SUB-COMMITTEE ON SHIP DESIGN AND
CONSTRUCTION
11th session
Agenda item 11

GUIDELINES FOR USE OF FIBRE-REINFORCED PLASTICS (FRP) WITHIN SHIP STRUCTURES

Comments on the fire integrity test method of FRP elements in the report of the Correspondence Group (SDC 11/11)

Submitted by China

Figure 1: Typical critical temperatures for an FRP composite sandwich (PVC core, polyester FRP)

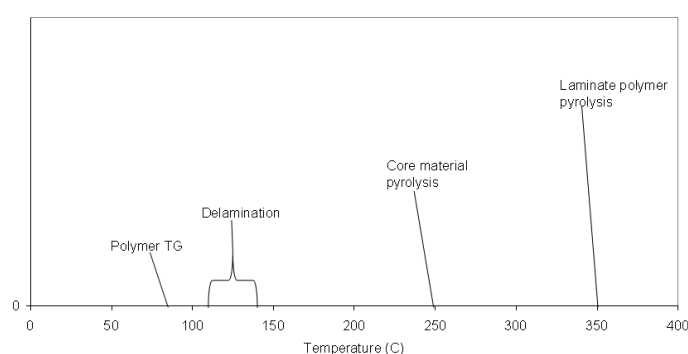
7 Some typical critical temperatures for an FRP composite sandwich panel including the polymer TG temperature, delamination temperature, core material pyrolysis temperature, and laminate polymer pyrolysis temperature are summarized in figure 1. It is observed from the figure that the delamination temperature and core material pyrolysis temperature are far lower than the laminate polymer pyrolysis temperature. Therefore, it is possible that FRP composite may experience the overall structural failure due to the pyrolysis of core material or delamination when the laminate skin is detached from the core well before the failure of the laminate skin.

Figure 2: The test temperature vs. the amount and rate of deformation during the fire resistance test of FRP sandwich construction

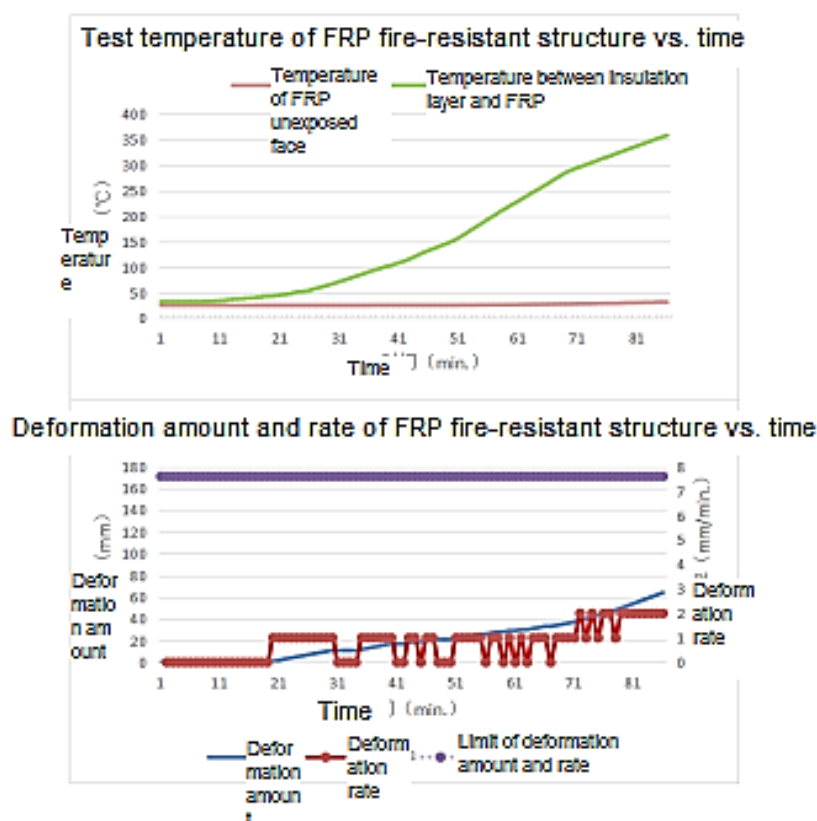
8 Figure 2 summarizes China's test results of fire unexposed side temperature of FRP, temperature between thermal insulation layer and FRP skin, and amount and rate of deformation during the testing of fire-resisting divisions of FRP sandwich construction. It is observed from the figure that when the temperature between thermal insulation layer and FRP skin exceeds the typical laminate polymer pyrolysis temperature, namely 350°C, there is no obvious change with the amount and rate of deformation of FRP fire-resistant structure, far below the ultimate load-bearing capacity of the core.

9 According to the above test results, when the laminate skin on the fire exposed side reaches the pyrolysis temperature, there may be no failure in the pyrolysis of the laminate skin due to its relatively low heat conductivity coefficient. The load-bearing capacity and fire-resistant integrity of the entire FRP construction may still be in a relatively safe condition.

Figure 3: The test temperature vs. the amount and rate of deformation during the fire resistance test of FRP sandwich construction

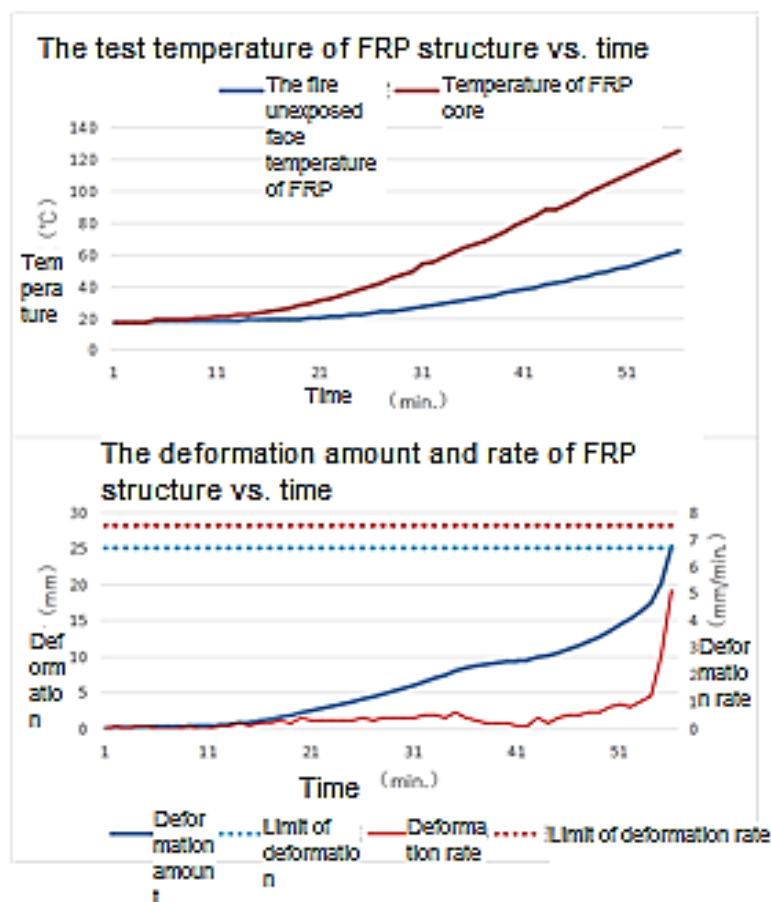
10 Figure 3 summarizes China's test results of fire unexposed side temperature of FRP, temperature of FRP core, and amount and rate of deformation during the testing of fire-resisting divisions of FRP sandwich construction. It is observed from the figure that when the FRP core temperature reaches the typical delamination temperature, namely 120°C, the deformation of core exceeds the standard limit of the structure and the rate of deformation rises sharply, exceeding the ultimate load-bearing capacity of the core. Therefore, it is feasible and meaningful to monitor the fire resistance performance of FRP divisions by monitoring the temperature between the core material and FRP laminate skin.

11 Therefore, it is necessary, but insufficient, to determine the fire resistance performance of composite structures by monitoring the temperature between the thermal insulation layer and FRP skin. It is, in addition, necessary to monitor the temperature rise underneath the FRP laminate skin based on the features of composite structures, so as to determine the fire resistance performance of FRP structure through the comprehensive consideration of the overall temperature rise of the FRP laminate skin.

- "1 insulation: Thermocouples should be placed on the fire exposed side underneath the insulation of the FRP division to measure the temperature of the FRP skin directly underneath the insulation layer(s). and thermocouples should also be placed on the fire exposed side underneath the FRP skin to measure the temperature of the core directly underneath the FRP skin. Thermocouple positions should be similar to those given in part 3 of the annex except that they are on the fire exposed side (i.e. to be placed under the insulation and under insulation joints). Any single temperature rise recorded by any of the individual unexposed side thermocouple shall not be more than the heat distortion temperature (HDT) of the polymer resin used in the FRP Composite."
